TECHNICAL BULLETIN

MODEL/DERIVATIVE:
Freelander

Bulletin N°: 0027
CDS. ref: L8663bu
Issue: 1
Date: 01.08.01

PROBLEM:
NOISE FROM TOP END OF ENGINE - TAPPETS

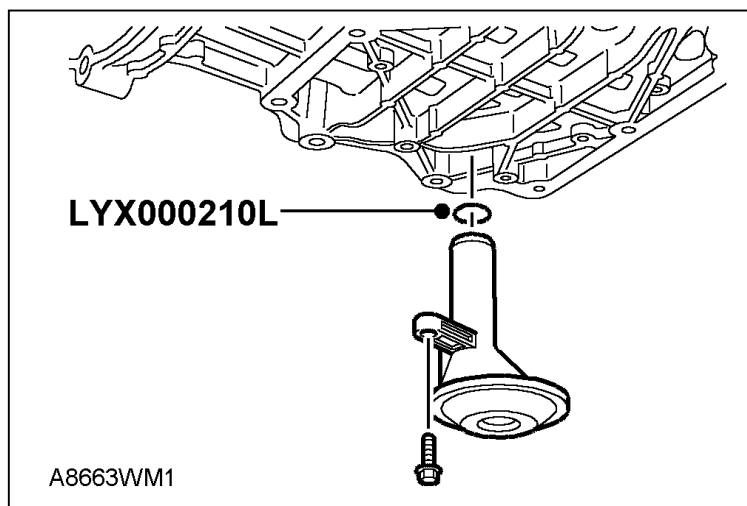
CAUSE:
The 'O' ring seal on the oil suction pipe may have been damaged during engine assembly.
This will allow air into the engine oil and will subsequently lead to noisy tappets.

ACTION:
To confirm a customer complaint of the above, allow the engine to idle from cold for 5 minutes.

If tappet noise persists, replace the 'O' ring seal with new seal, part number LYX000210L.

In the unlikely event that the oil suction pipe is damaged replace with new assembly, part number LSP000040L which includes the new 'O' ring.
